Work Plan for Leaching Analysis of Hydro Pit Fill, Revision 1
Three Kids Mine
Henderson, Nevada

Re: Work Plan for Leaching Analysis of Hydro Pit Fill, Revision 1
Three Kids Mine, Henderson, Nevada

Appendix A
Response to NDEP Comments

Figure 4

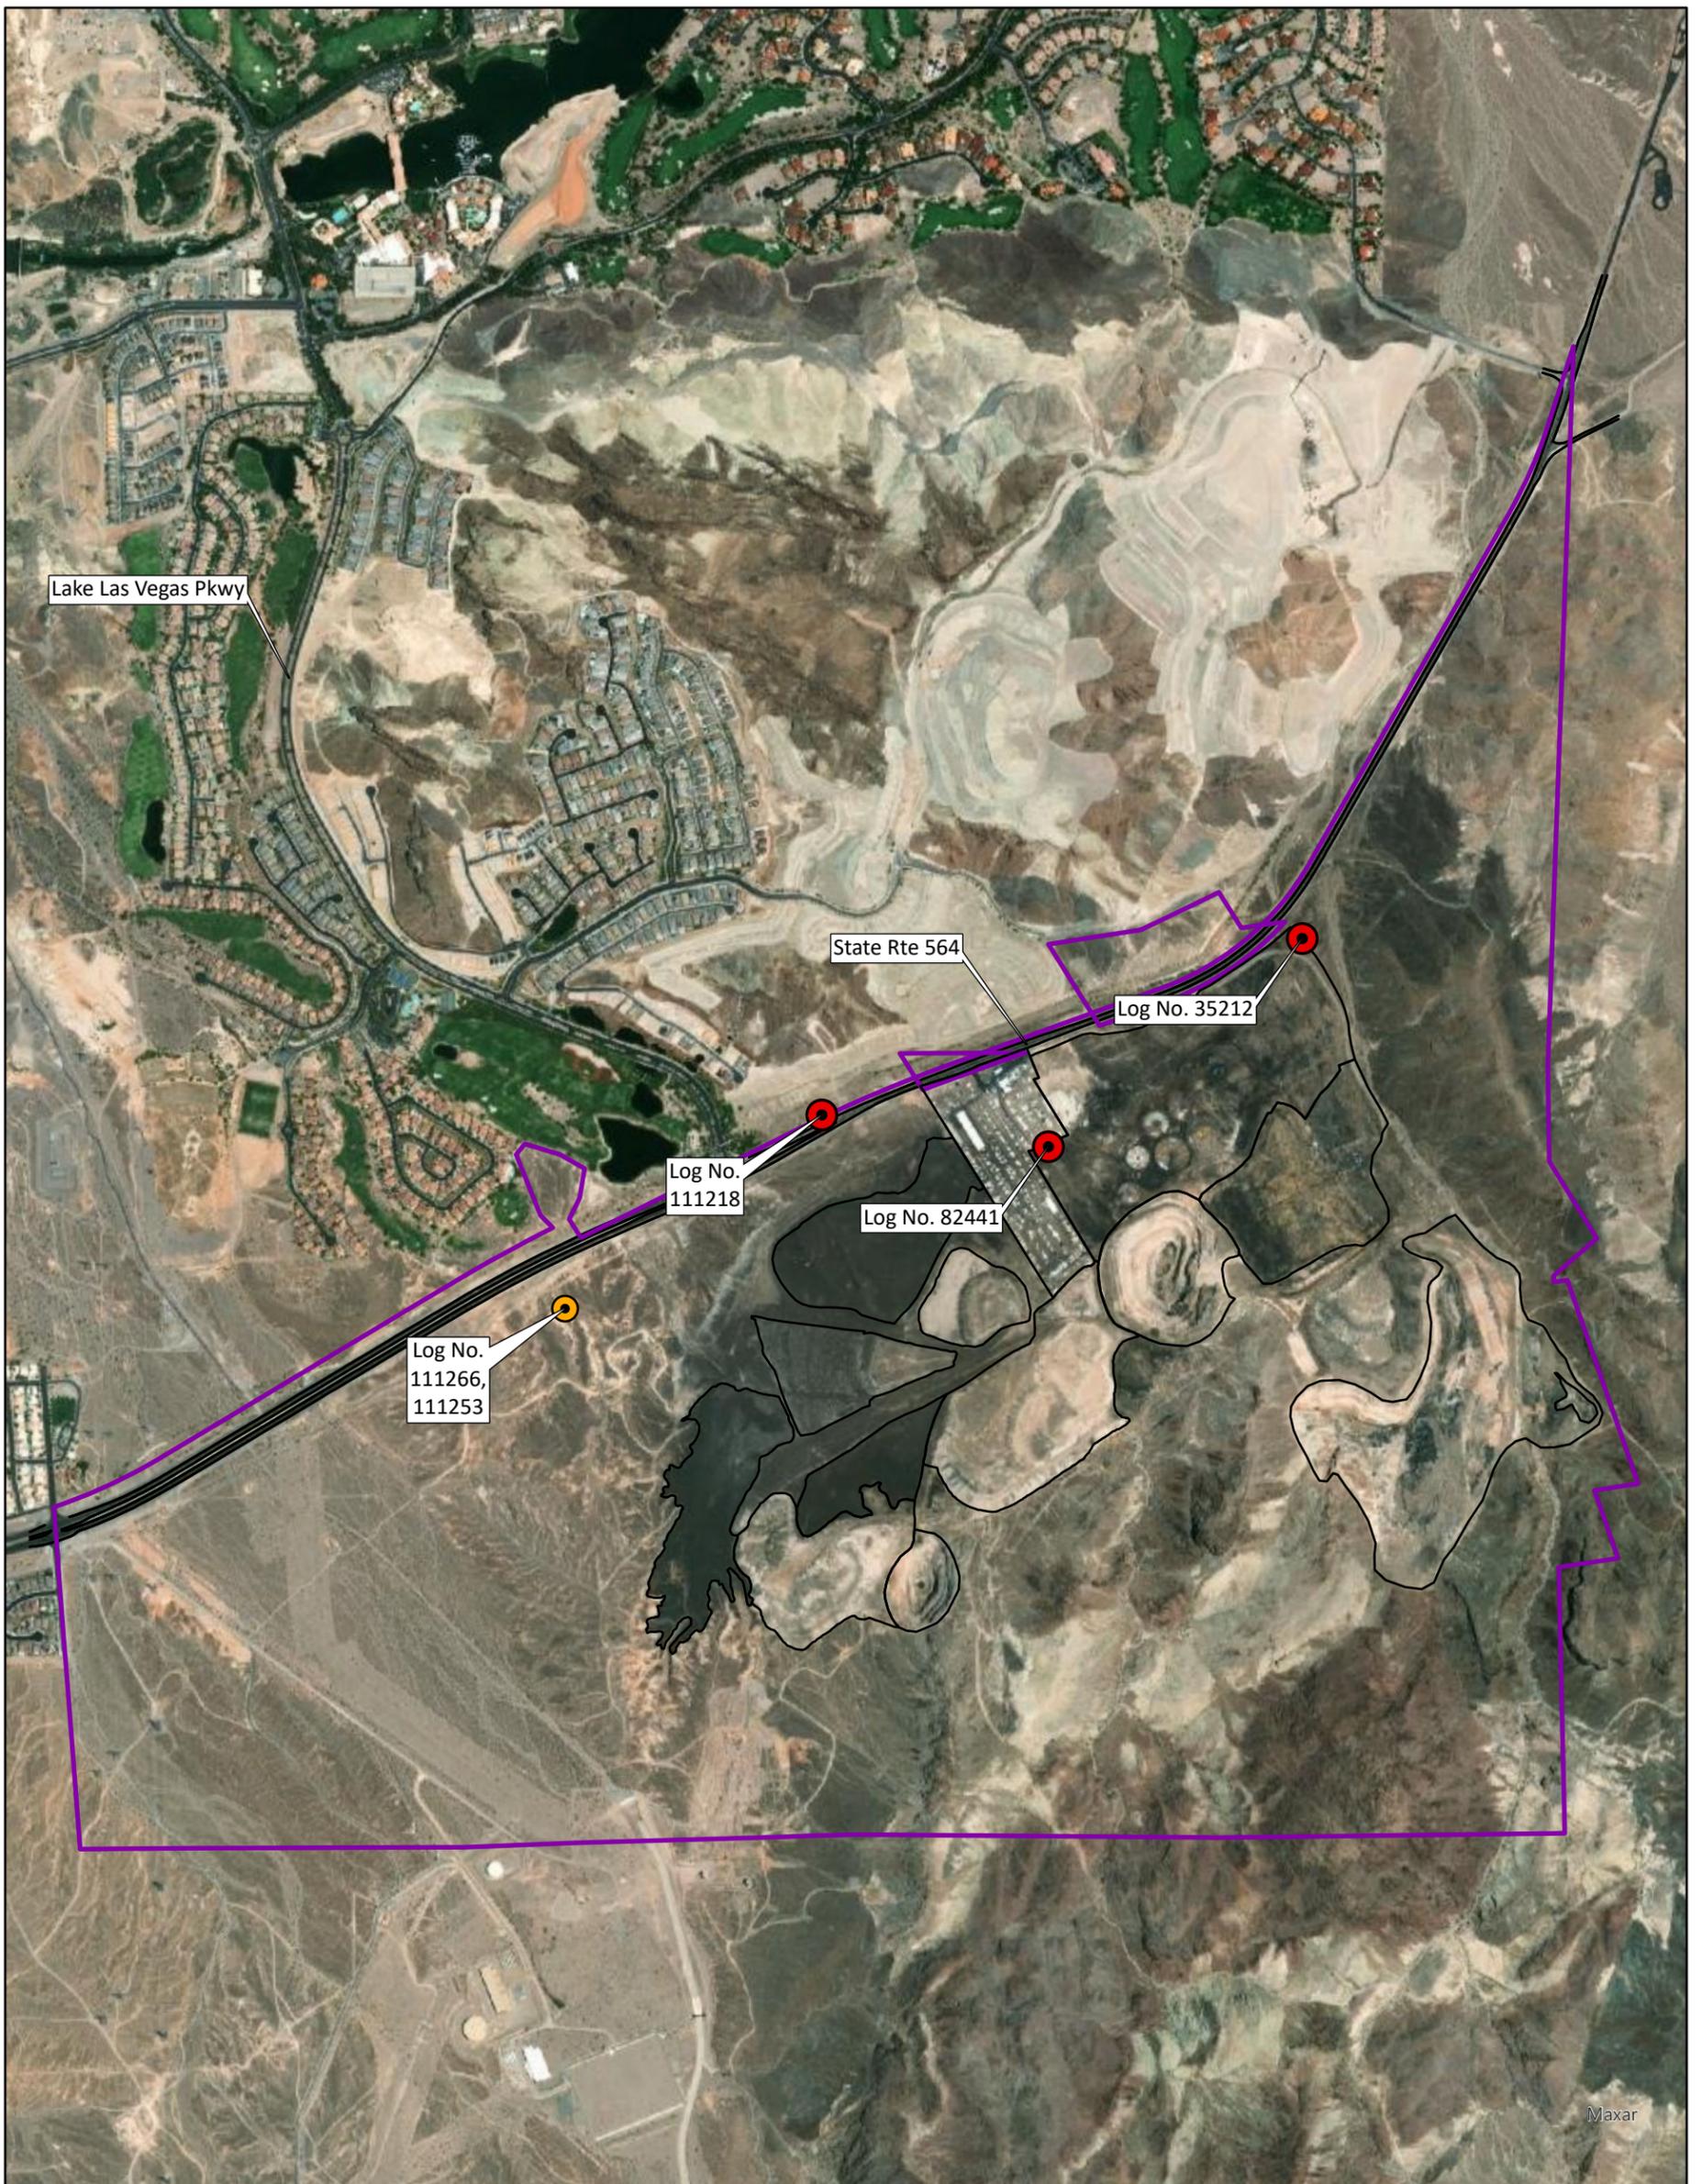
12. **Section 1.2.4 Groundwater** – Although this section includes references to the Phase II SAP, it would be helpful for the work plan to include a map of the groundwater well locations, approximate elevation contours, and well logs since potential groundwater concerns are a factor in this leaching analysis. Inclusion of these items would help add context to the groundwater elevations/depths, potentiometric surfaces, and hydraulic gradients described in this section.

A map depicting well locations and well logs have been added as Figure 4 and Appendix B, respectively.

Figure 5

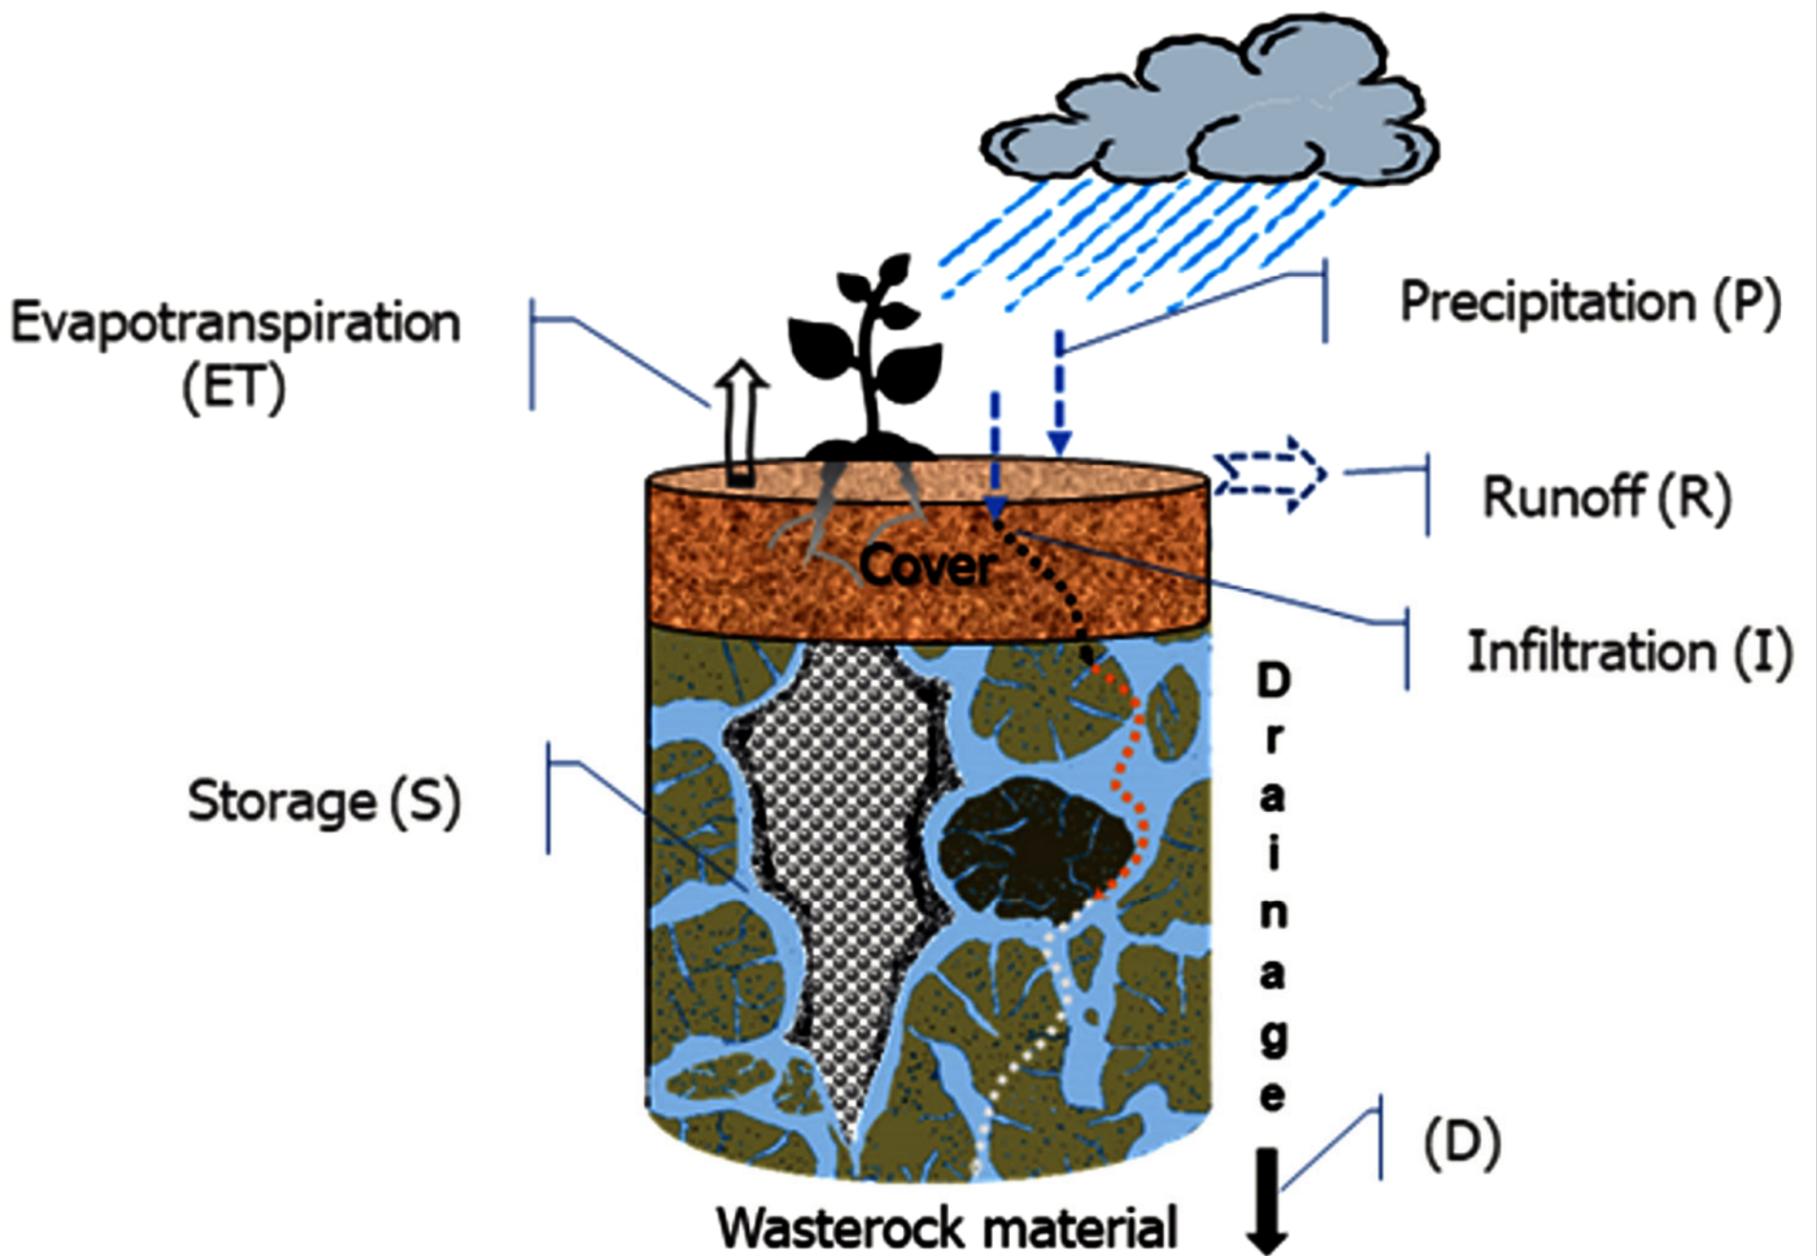
7. **General Comment #7** – The transport models should be examined to ensure that, to the extent practicable, they mathematically incorporate the key physical/chemical processes noted in the conceptual infiltration model (Figure 4), as well source release mechanisms.

Agreed. The conceptual model in Figure 4 illustrates the principal mechanisms of precipitation and infiltration and this input has been derived from climate datasets. The hydraulic properties of the solid matrix have also been characterized. The conceptual model for geochemistry involves many different reactions that will occur between solid, liquid, and gases that will exist in the backfilled pits and reclaimed areas subsurface. The primary components are known from the site geological descriptions plus accounts of mining and milling practices. In addition to SRCs, the whole rock chemistry and mineralogy of the mine wastes and native ground has been studied and characterized during the RI.
